# HISTORIC AND DESIGN REVIEW COMMISSION

September 18, 2019

**HDRC CASE NO:** 2019-463  
**ADDRESS:** 111 BOSTON  
**LEGAL DESCRIPTION:** NCB 578 BLK B LOT 7&8  
**ZONING:** RM-4, H  
**CITY COUNCIL DIST.:** 2  
**DISTRICT:** Dignowity Hill Historic District  
**APPLICANT:** Robert Lee/LINDLEE LLC  
**OWNER:** Robert Lee/LINDLEE LLC  
**TYPE OF WORK:** Construction of a 2-story residential structure  
**APPLICATION RECEIVED:** August 09, 2019  
**60-DAY REVIEW:** October 08, 2019  
**CASE MANAGER:** Edward Hall

The applicant is requesting conceptual approval to a 2-story, single family residential structure on the vacant lot at 111 Boston, located within the Dignowity Hill Historic District. The applicant has proposed for the structure to feature approximately 1,630 square feet.

**CONTEXT**  
SCALE: NS

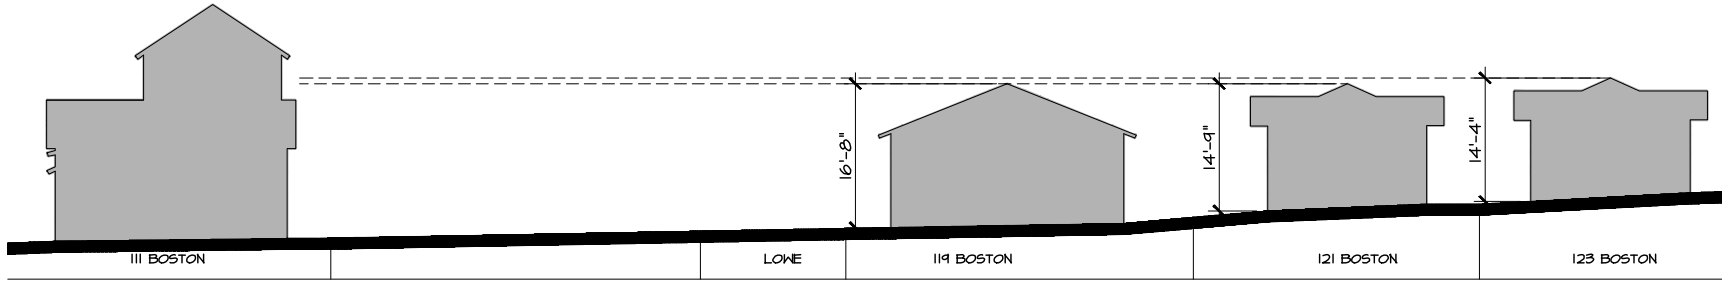
- h. SCALE & MASS – Per the Guidelines for New Construction 2.A.i., a height and massing similar to historic structures in the vicinity of the proposed new construction should be used. In residential districts, the height and scale of new construction should not exceed that of the majority of historic buildings by more than one-story. The applicant has proposed an overall height of 27' – 2". The existing structures on the block each feature one story in height. Boston alley features a decrease in elevation from east to west. The applicant has submitted a street elevation noting the proposed new construction, the existing structures on the block, and the change in grade and elevation; however, this diagram does not include the most adjacent historic structure.

- iii. That the most adjacent historic structure to the west of the proposed new construction be included in the street elevation diagram.
- iv. That composite siding feature an exposure of four (4) inches, a thickness of  $\frac{3}{4}$ ” and mitered corners; that standing seam metal roofs feature panels that are 18 to 21 inches wide, seams that are 1 to 2 inches in height, crimped ridge seams, or and a standard galvalume finish; and that a uniform roofing material be used throughout, as noted in finding m.

**1 FRONT/SOUTH ELEVATION**  
SCALE : 1/8" = 1'-0"

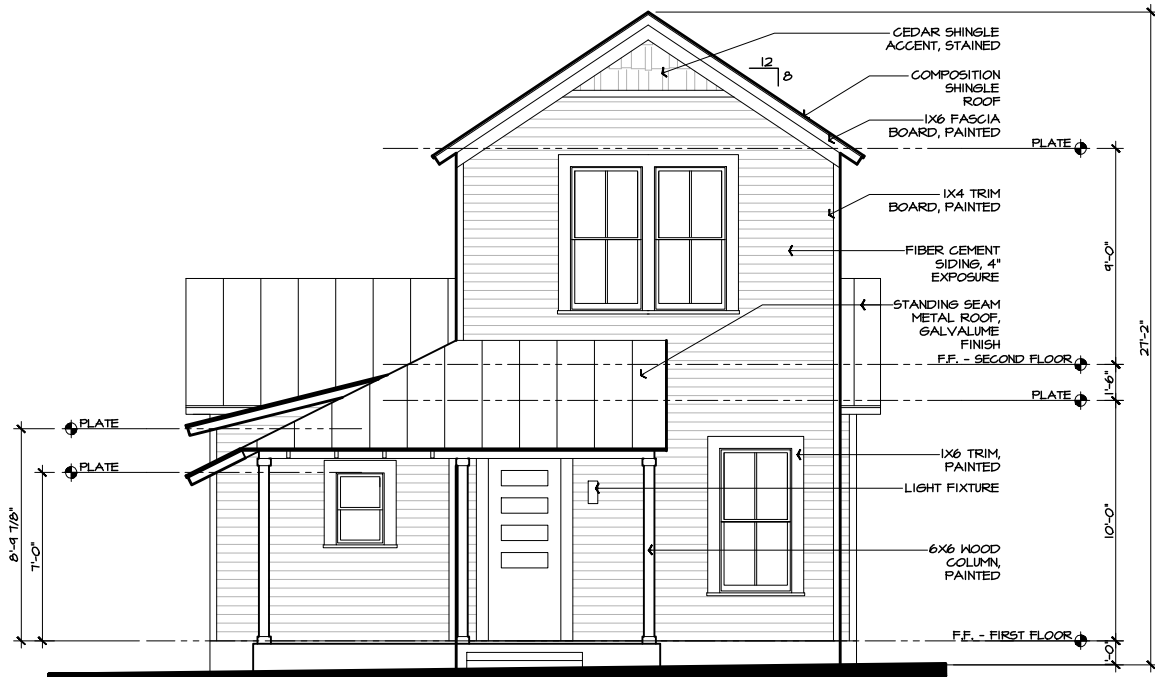
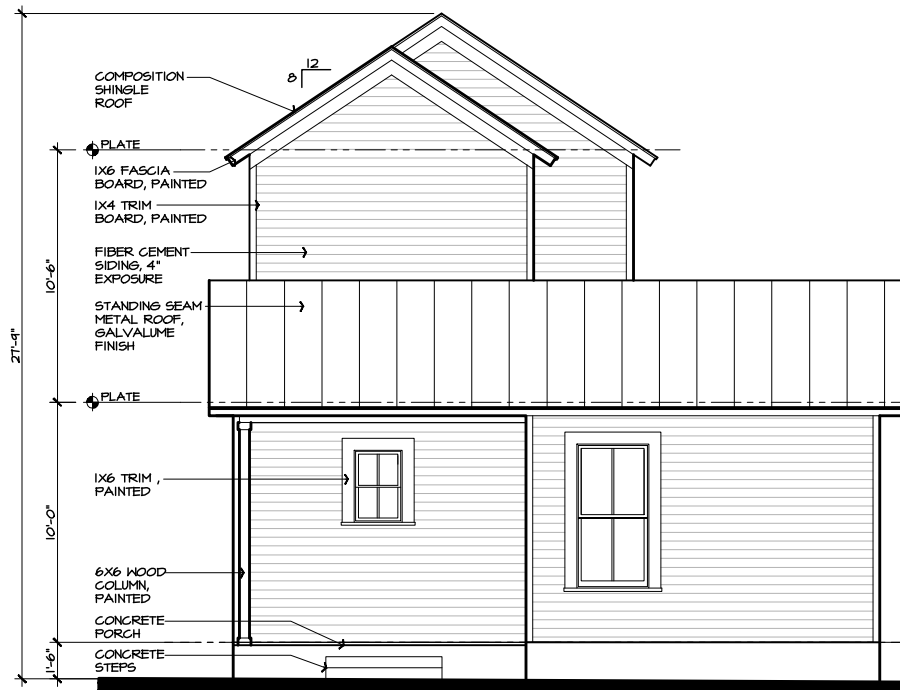
- k. ROOF FORMS – The applicant has proposed roof forms that include front and side facing gabled roofs, rear facing hipped roofs, and a hipped porch roof. These roof forms are found historically within the Dignowity Hill Historic. Staff finds the proposed roof forms to be appropriate and consistent with the Guidelines; however, staff finds that the proportions of the porch roof should be modified for the proposed porch roof to feature a shallower pitch than what has been proposed.

- o. **ARCHITECTURAL DETAILS** – Generally, staff finds the proposed architectural details to be appropriate; however, the applicant should continue to study fenestration patterns and reduced massing. Additionally, as noted in the above findings, staff finds that the proposed porch roof form should be modified to feature a shallower pitch and should extend across the entire front façade of the historic structure.

- i. That the applicant continue to study ways to reduce the proposed massing on the street elevation to be more consistent with those found historically on the block. An increased front setback could also contribute to the perception of reduced massing as noted in finding i.

- ii. That the applicant continue to revise the proposed wrap around porch roof and to achieve a shallower roof pitch and that the porch roof extend across the front facade as noted in finding k.
